Drainage Board

New Bridge for Union Gas (Part Lot 1, Con. 3) and Updated Maintenance Schedule of Assessment

Geographic Township of Colchester South, Project REI2016D061, Town of Essex, County of Essex REI Project 2016D061, Town of Essex, County of Essex

WEST TOWNLINE DRAIN
Bridge for Union Gas (Part of Lot 1, Concession 3) and
Updated Maintenance Schedule of Assessment
Geographic Twp. of Colchester South
Project REI2016D061
Town of Essex, County of Essex

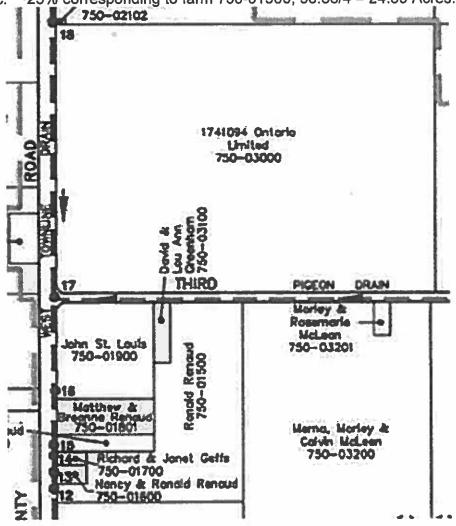
In this letter I am objecting and contesting the inconsistencies that are presented in your schedule of value liability (Total Value = value of benefit + value of outlet liability) that are assigned to my property tax roll number 750-03000, that belongs to 1741094 Ontario Limited corporation. I am also objecting and contesting to calculated "affected area" of the same farm that are included within the watershed area of the WTD.

- 10. I am also contesting the unnatural perfect stepwise distribution of the watershed area of the WTD as presented in your map. This is clearly intended to include all of the acres of my property as "affected acres," while my neighbors to the east and north have only portions of their farms included as "affected acres." We know for fact that the eastern 40% of 750-0300 including the pond and beyond is not tiled and the rest of the farm is poorly tiled with very old clay tiles most of which are not currently functioning. I am requesting that at least 30 acres of the north-eastern portion of my farm 75-03000 be not considered as affected acres. I am requesting that the total "affected acres" of my property be reduced to no more than 98.36 -30 = 68.36 acres.

considered as affected acres. I am requesting that the total "affected acres" of my property be reduced to no more than 98.36 -30 = 68.36 acres." Response: As noted on the plan, the watershed line is approximate. It was set to encompass the past affected areas of each parcel and reflects the current practice of organized drainage systems and patterns. If information is provided to us that is more accurate for the boundary, the line can be adjusted, but the affected areas will remain as per the past drainage reports unless valid information is provided on changes to the drainage in the area. The 30 acres at the northeast corner of the Shehadi parcel are not assessed to any other drainage system that we are aware of. All lands within the topographic watershed need to be assessed for drainage and cannot be excluded. Drainage assessments consider both subsurface and surface flows, particularly during frozen ground conditions, and the contouring in this area and past assessments indicate that the flows from the 30 acres go to the West Townline Drain for their outlet. Municipal drains provide outlets for the affected lands. Having that outlet is a benefit to the lands and gives the lands the opportunity to use the drain for enhancing their drainage of the lands. Regardless of whether the owner chooses to repair or enhance his tile or surface drainage, the benefit to the parcel is there to use at any time and the lands need to be assessed for their ability to have enhanced drainage and productivity, in accordance with standard assessment practice pursuant to the Drainage Act. Therefore we cannot recommend any adjustment to the affected area of the Shehadi parcel.

EXHIBIT A

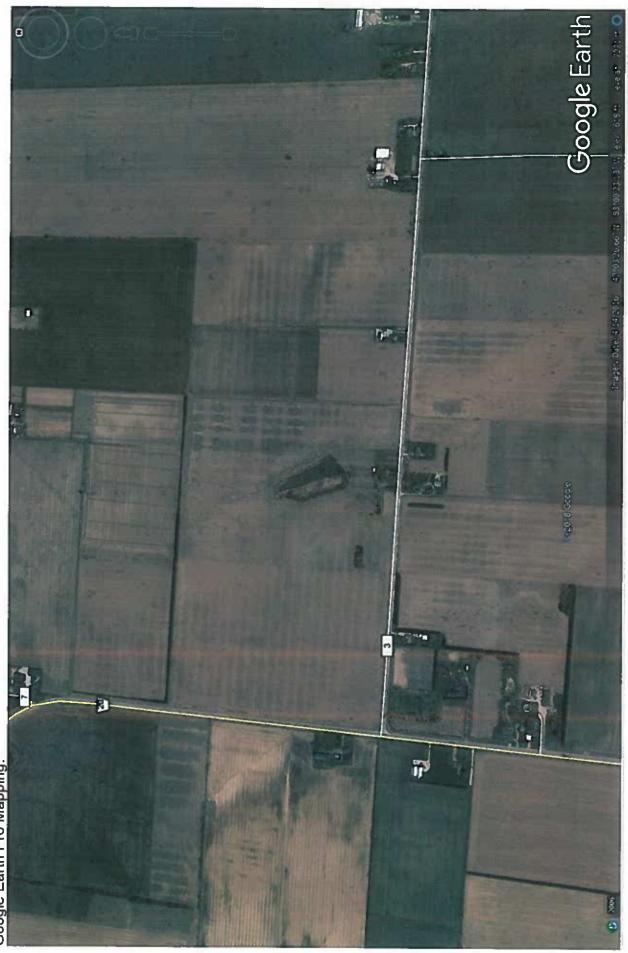
The idea of including the whole farm 750-03000 as draining directly into the West Townline Drain (WTD) is incorrect. Portions of this farm drain into the Pigeon Drain (Exhibit B). The most important question that I request an answer to is, how the engineer arrived to the figures listed in his schedule of assessments? What is the basis of his calculations? There must be a mathematical formula and basis for these value assessments, otherwise, these figures in the report are incorrect and corrupt.

- All of your farm drains into the West Townline Drain. We recognize that there are 4.65 hectares of the total 39.8 hectares of the farm that are assessed to the Pigeon Drain. This drain outlets directly to the West Townline Drain. The area to the Pigeon Drain is not significant as you have stated since it is only approximately 11.7% of the overall area and we believe that this was accounted for in the past drainage reports that were accepted by the owners at that time.
